Final Environmental Impact Report on the

Natomas Levee Improvement Program
Phase 3 Landside Improvements Project

State Clearinghouse No. 2008072060

May 11, 2009

PAGE H-7

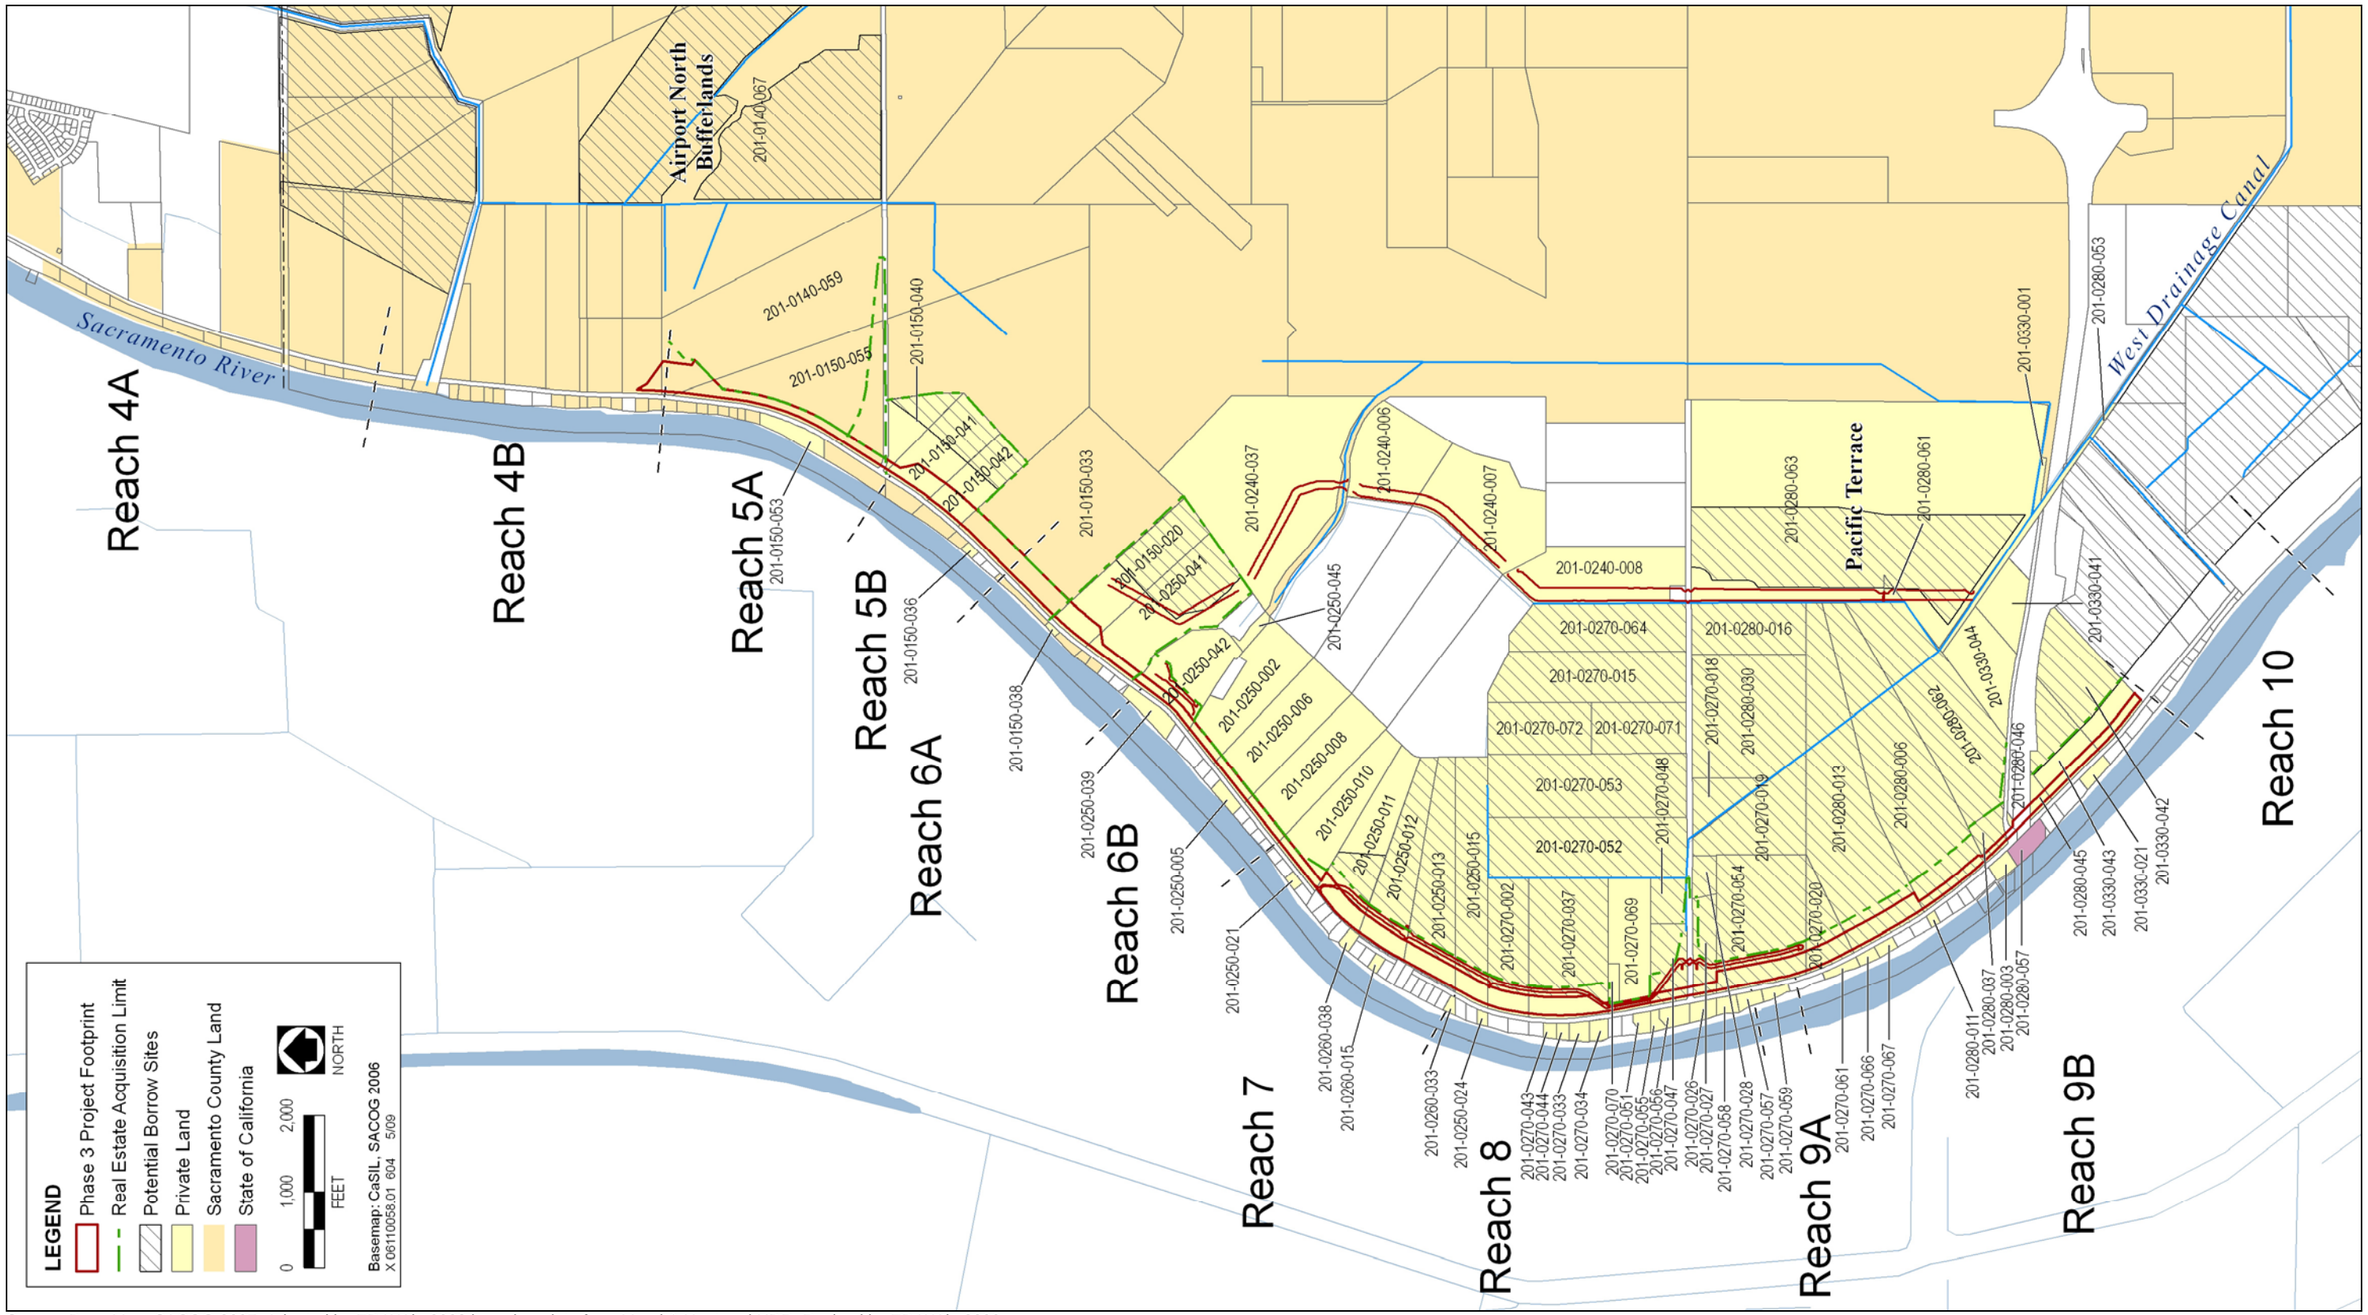
In Section 2.3.7.4, also on page 2-27, the first paragraph of the section discusses Plate 17c showing the footprint for Phase 3 Project work on the NEMDC. However, Plate 17c does not show any take lines, so adjacent property owners do not know what the actual impacts will be on their properties and how much of their property will be taken. Again, if the document is a project-level document, why isn't this issue resolved, and then analyzed on the DEIS/DEIR? O4-6 Cont.

To clarify which parcels would be subject to real estate acquisition under the proposed project, Exhibit H-1b has been revised to show a maximum real estate acquisition limit.

Figure 8-1
Wells In and Near the Natomas Basin

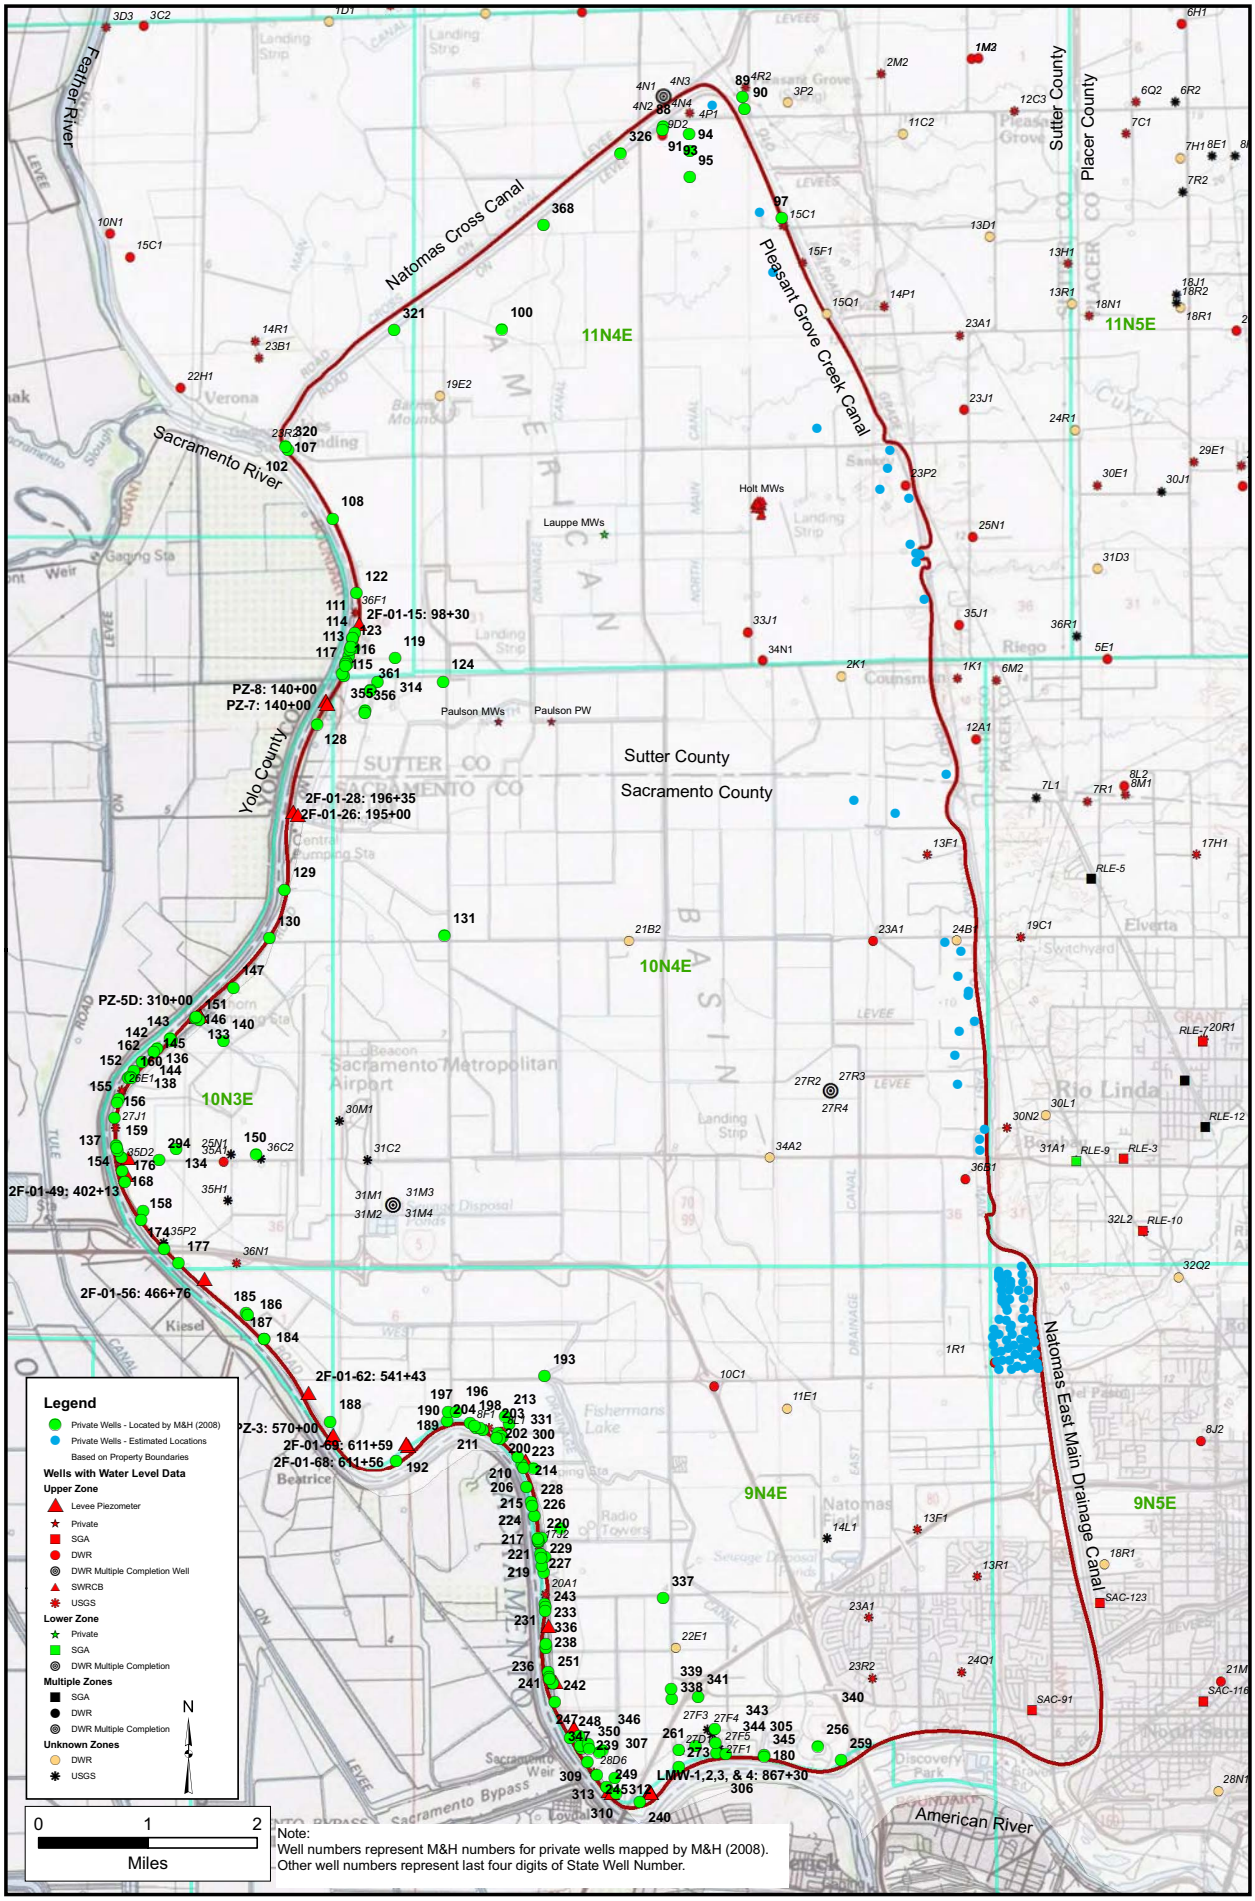
Page 4.4-14. Under Impact 4.4-c, Effects on Groundwater, a review of Appendix B2, by Luhdorff + Scalmanini (LSCE), shows that impacts of cutoff walls on wells in VVA cannot be known or described, because the LSCE report, as shown in Figure 8-1 thereto, shows no wells serving the VVA community at all. As mentioned above, all the homes within our community are served by domestic wells. O4-15

Page 5-21. Again, the LSCE report failed to address impacts to the VVA community's domestic wells, as they are omitted in Figure 8-1 of the LSCE. O4-25

Figure 8-1 shows wells with known or estimated locations in and near the Natomas Basin. "Private wells" shown along the Sacramento River East Levee and the NCC South Levee are primarily domestic wells mapped by M&H (Stephen Sullivan, pers. comm., January 23, 2008) but include some irrigation wells. Well numbers provided for these wells correspond to numbers assigned by M&H. Similar mapping of private wells along the PGCC and NEMDC West Levees is still in progress, and well locations along the eastern edge of the Natomas Basin shown on **Figure 8-1** are estimated based on parcel boundaries. Only a portion of the estimated well locations in the Valley View Acres (VVA) community, located along the NEMDC north of Del Paso Road and east of Sorento Road, are shown on the map due to the high density of domestic wells in this area.

In addition to domestic wells, **Figure 8-1** also shows wells with water level data mapped by LSCE based on locations provided by DWR and other sources. Symbols used for these wells indicate the depth zone (upper, lower, multiple, and unknown). Most of these are agricultural wells, M&I wells, or monitoring wells. If available, the wells are numbered based on the last four digits of the State Well Number.
